St Johns Lodge

151 High Street, Lindfield.

Design and Access Statement – August 2025

Proposed Site Plan

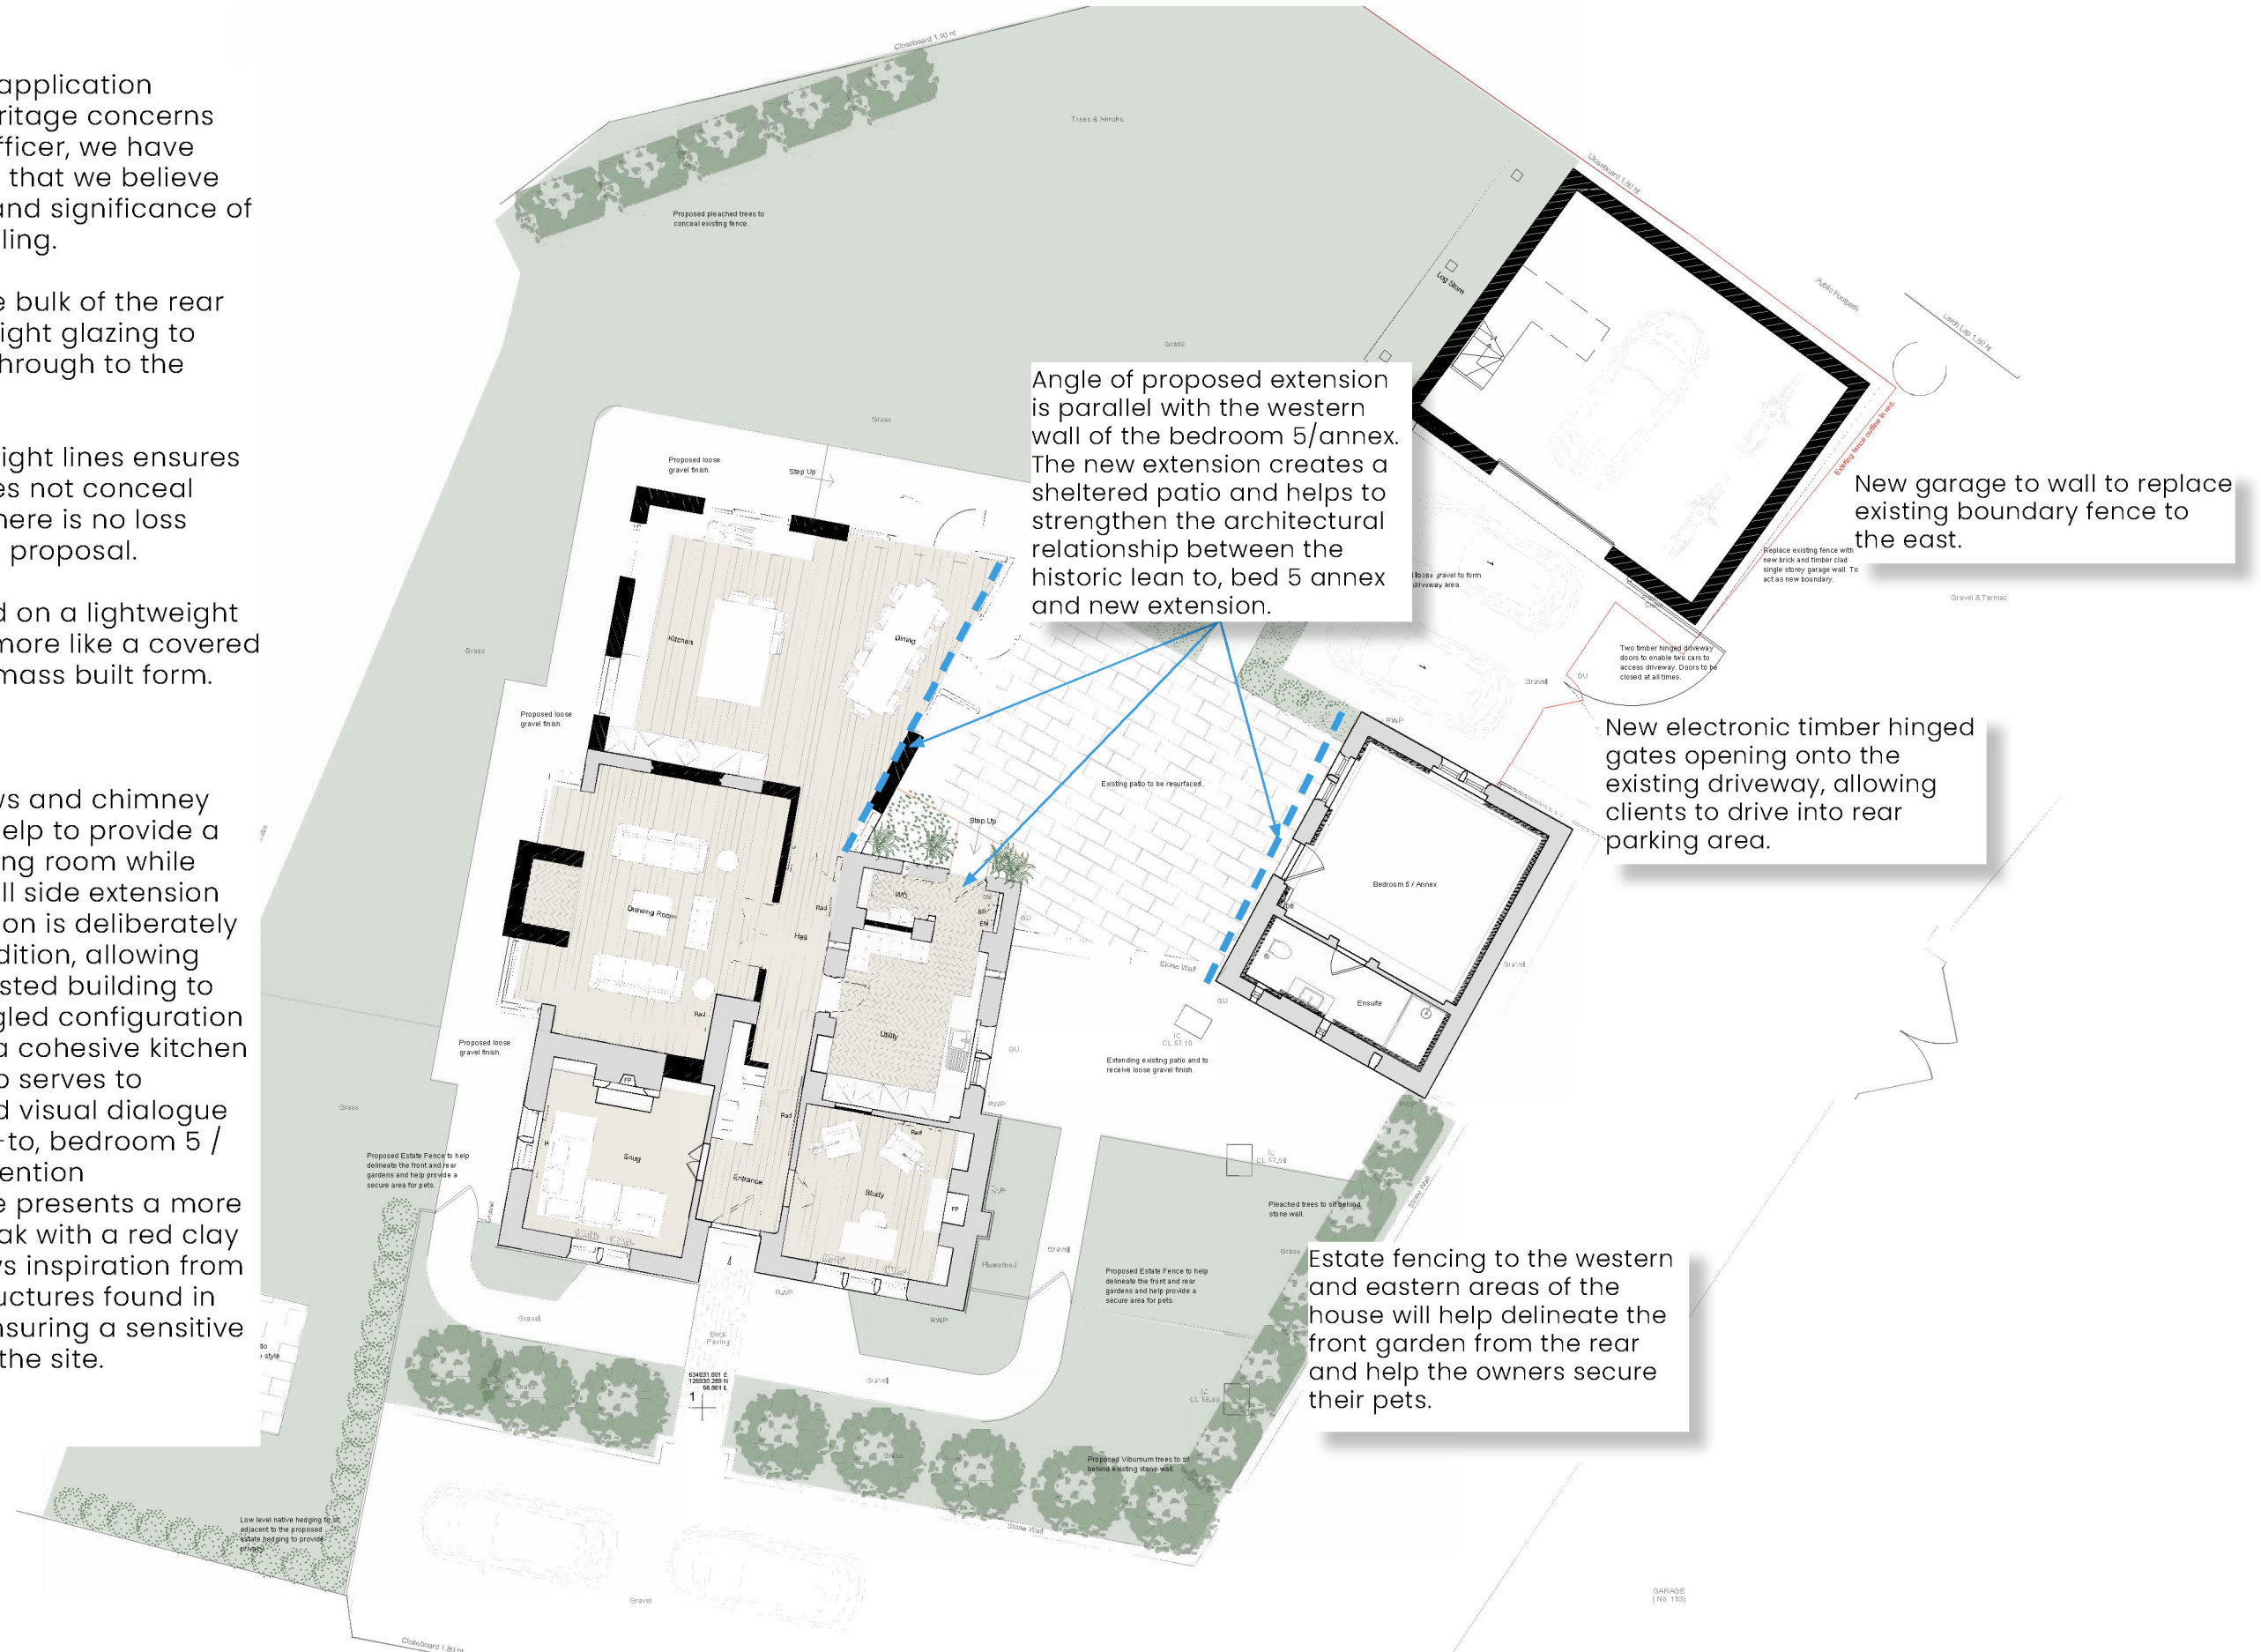
The existing garage building is modern and is not of any special interest. It is not particularly attractive, and tends to detract from views of both the listed Lodge and the former school building (likely NDHA) opposite. Its removal is therefore welcomed, subject to detail of an appropriate landscaping scheme to make good the area, which I would suggest should include as much soft landscaping as possible.

The proposed replacement garage building and bike store is on a larger footprint, and will result in some loss of garden space, in particular due to the associated access and hard-standing. However, it is arguably more sensitively located than the existing garage being to the rear of the Lodge and of the buildings fronting onto the High Street including Blacklands and Firs Cottage, and adjacent to an existing access driveway running across the back of these properties. On balance, and subject to detail including of the building itself, the proposed alterations to the boundary adjacent to it, and the associated landscaping, this aspect of the proposal is not considered contentious.

Please our accompanying proposed site plan with details of hard and soft landscaping for this area. We have designed the landscaping to compliment the setting of the listed property.

The revised proposals include proposed elevations as-well as a site elevation to show the relationship with the boundary. See accompanying drawings for more information. We have adopted a subservient architectural typology to ensure the building is sympathetic to the main house and bed 5/annex.

Proposed Ground Floor Plan

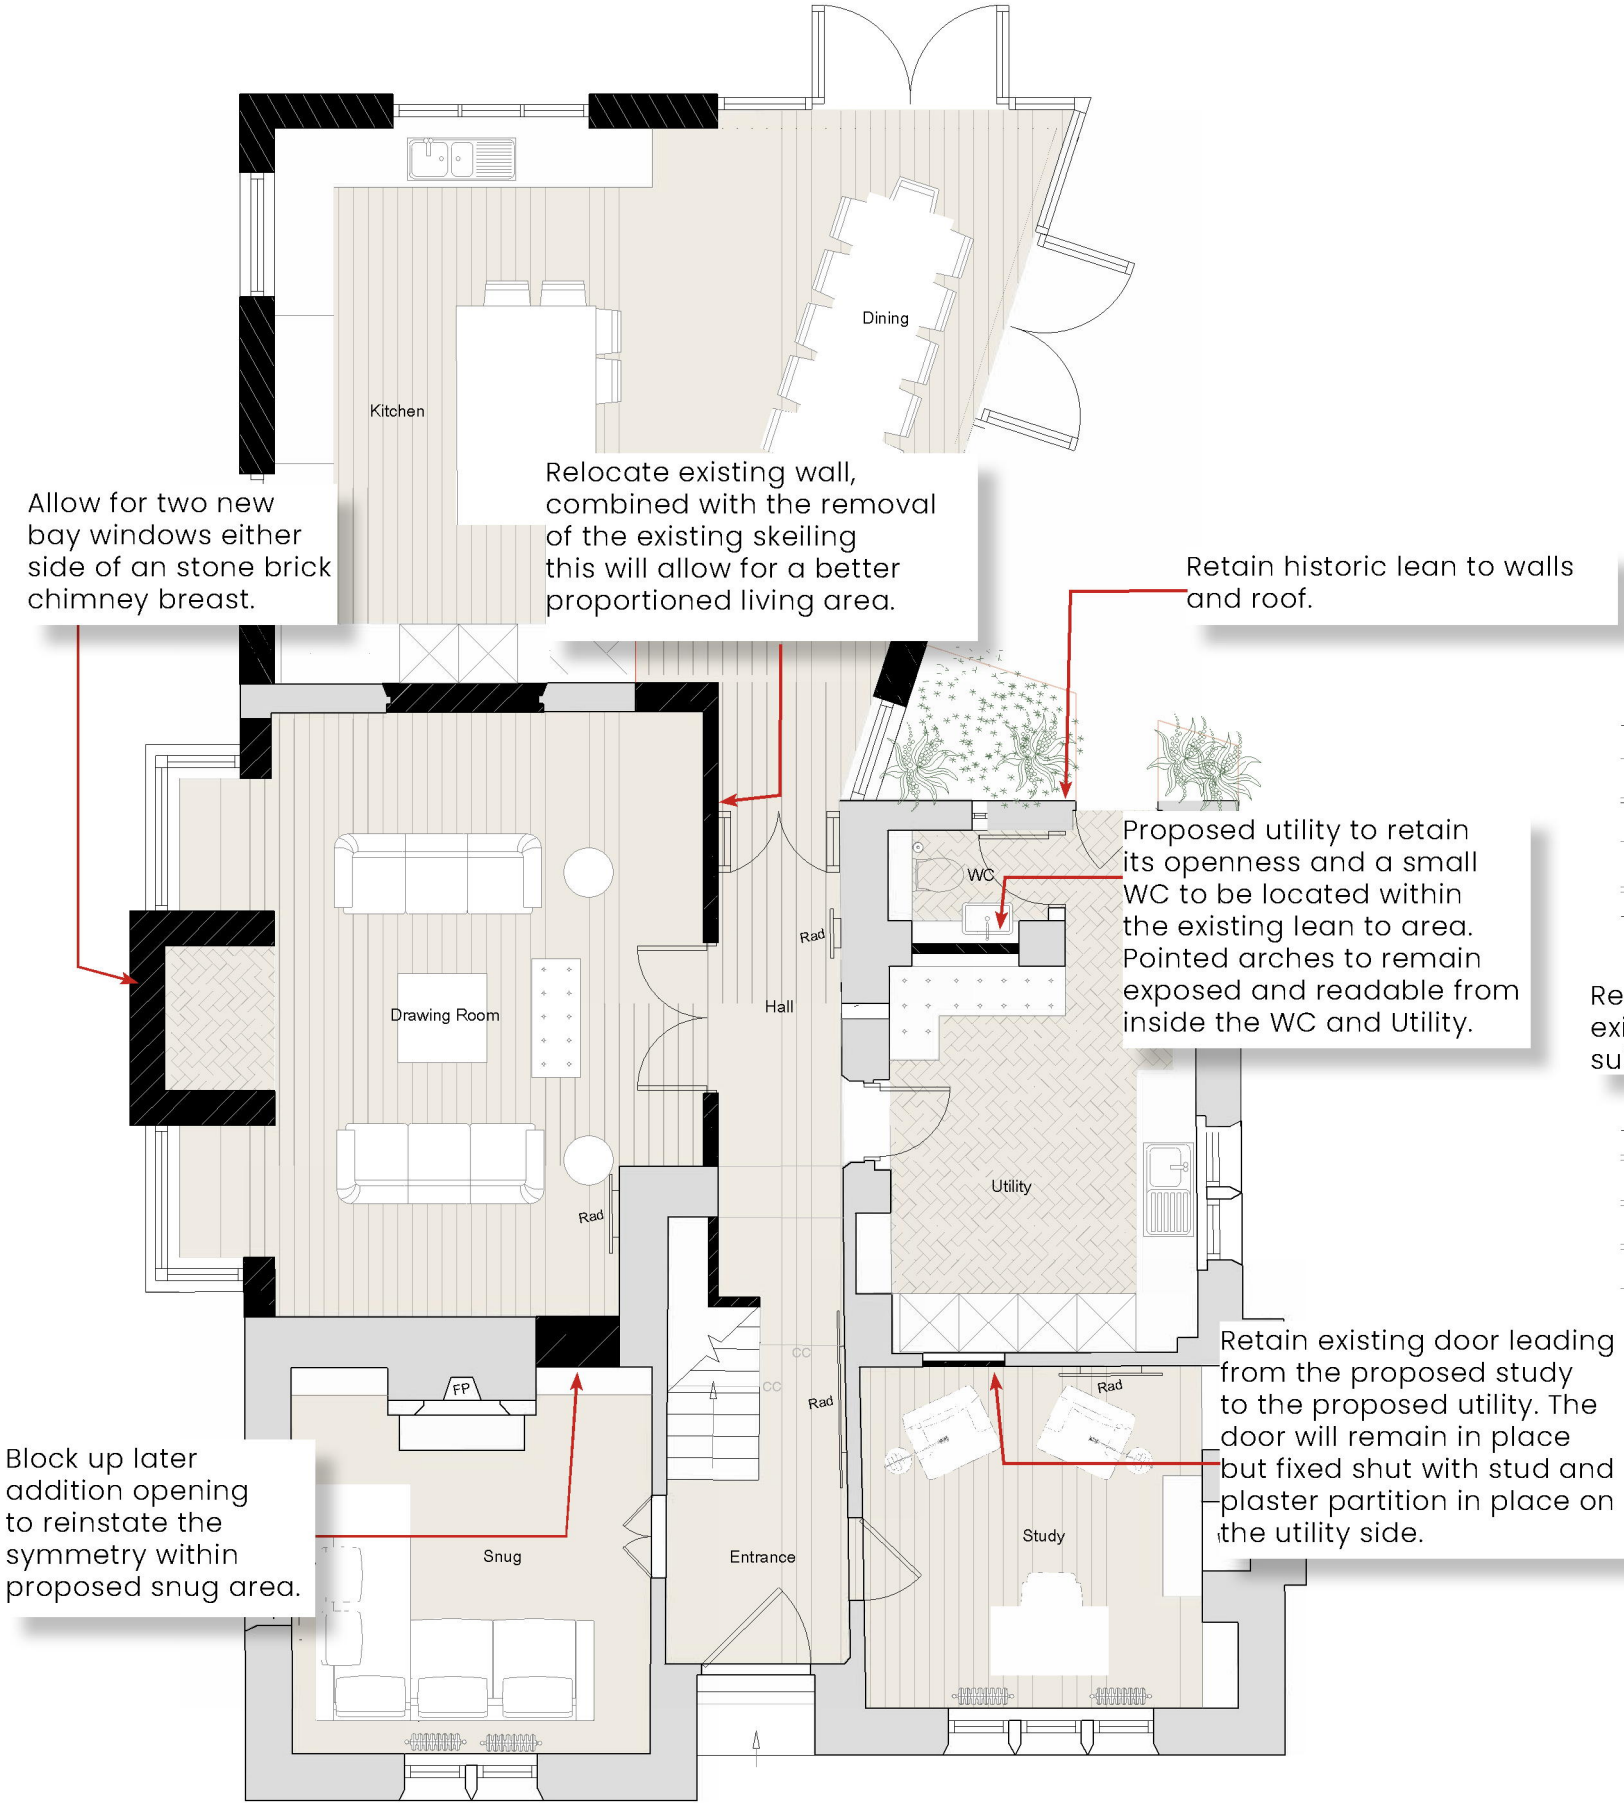
The proposed internal alterations are principally within the modern extension and therefore not considered contentious, however the creation of new partitioning within the rear service range at ground floor (originally suggested to be the kitchen) to create a WC would seem to adversely affect the surviving original proportions of this room as well as blocking one of the arched openings leading into the original lean-to. This aspect of the proposal therefore requires reconsideration.

The proposal also includes blocking an existing, original doorway between the study and kitchen- I would agree with the commentary in the Impact Assessment which suggests that this door should be retained and fixed shut rather than removed, and the opening in-filled. Subject to detail of this amendment, this aspect of the proposal is not considered contentious.

We have taken your comments on board and adjusted the proposal, relocating the ground floor WC to within the historic lean to. This redesign preserves the existing proportions of the kitchen (proposed utility room). This proposed change allows for the retention of the pointed archways, with only one partially blocked but is still entirely visible from within the proposed utility space and WC area.

Noted. We also agree with this point and will follow the guidance contained within the Impact Assessment.

Proposed Western Elevation

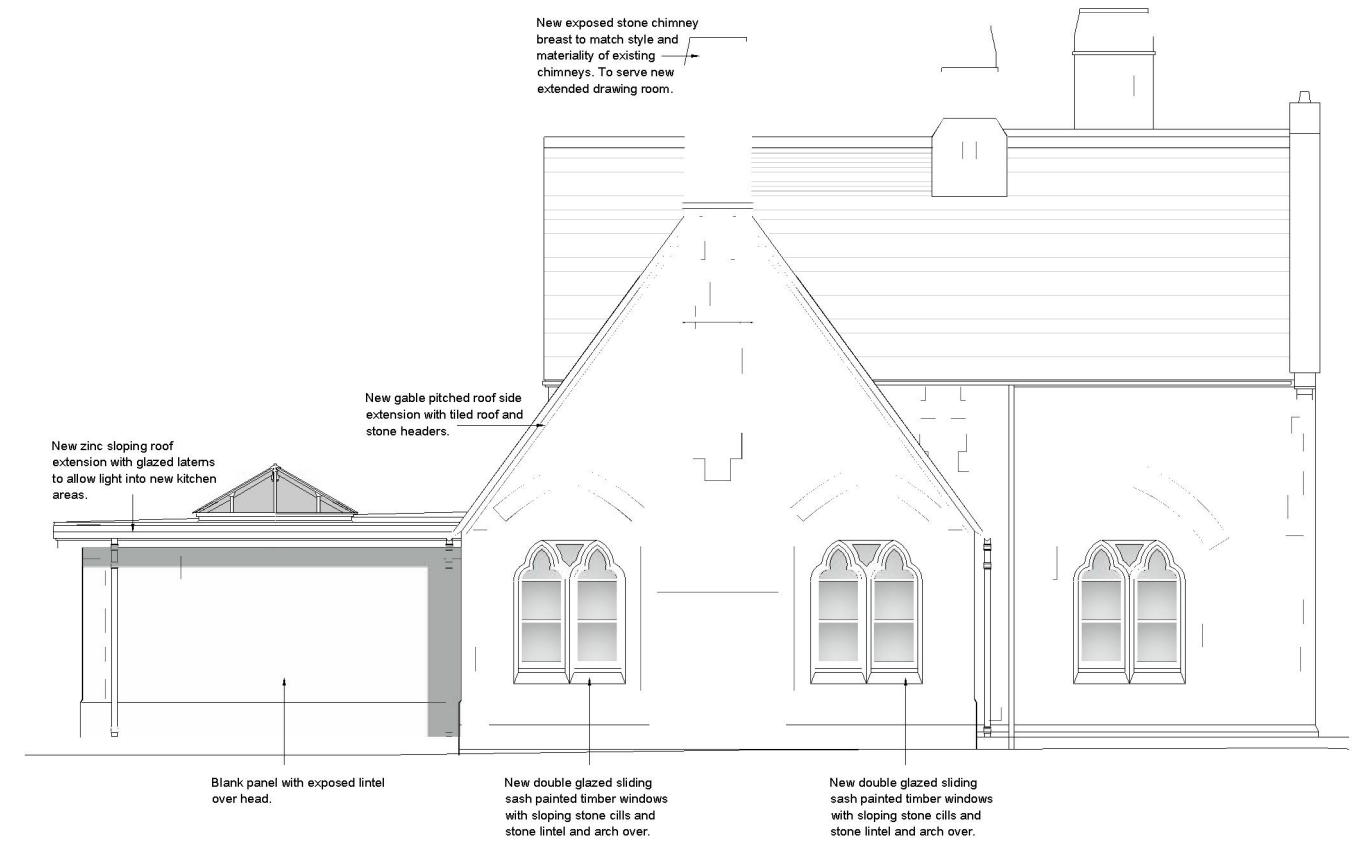
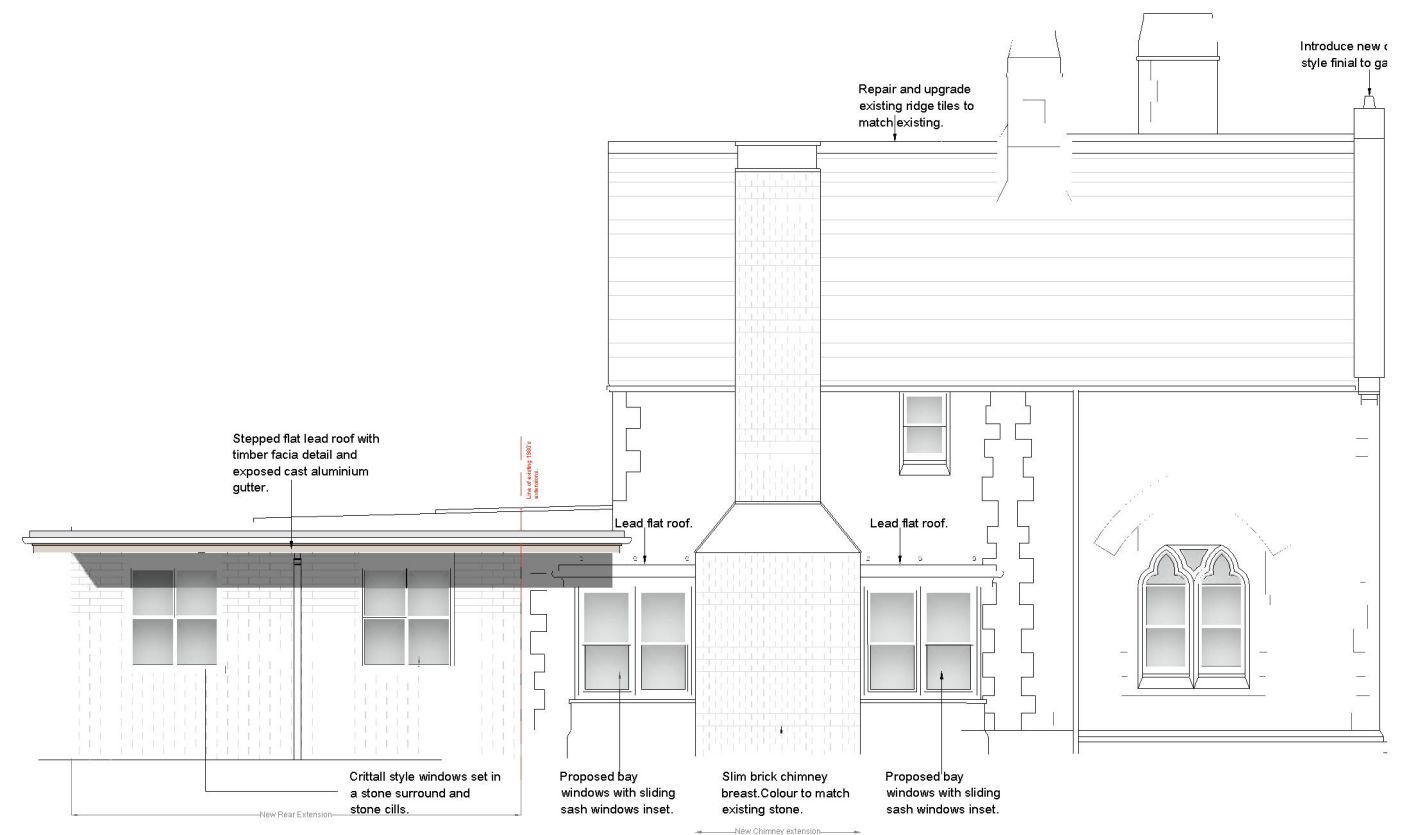
The proposed side extension is in my opinion contentious in principle - given the scale of the existing two storey infill extension to this part of the building, any further substantial addition to it is, as noted above, likely to prove contentious. This position to the side of the building is relatively prominent in key views looking from the south towards the building's principle façade, and the addition would in my opinion unbalance the elevation, which is a completed composition. This is in terms of both the projection of the gabled addition and of the attached chimney stack. I also consider that, although I understand the intention of the proposal to introduce more visual interest to the existing rear extension, the form and design of the further addition now proposed, including the prominent chimney stack, the fenestration and other detailing, in mimicking the architecture of the original house tend to detract from the existing relatively clear definition between the core of the building and the additions to it, confusing its narrative. I would therefore recommend that this aspect of the proposal is not pursued.

Our initial proposal of a gabled roof side extension that we felt addressed these concerns was unfavourable during the pre application stage.

As part of the revised proposal we have taken your comments and concerns on board and have removed the side extension in its entirety. The proposal allows for 2 bay windows either side of a proposed chimney ensuring this is subservient but does enhance this elevation which is currently void of any architectural features and thus detrimental to the historic building. As seen

Determined to improve this elevation, we are proposing a more pared back approach with bay windows and a brick chimney breast.

The proportions of the bay windows are taken from the adjacent pointed arch windows found in the original house. They will allow for better connectivity to the rear side garden, allow more daylight to flood the lounge area and the new lead roof will replace the lean to tiled roof and remove the skelting design internally.
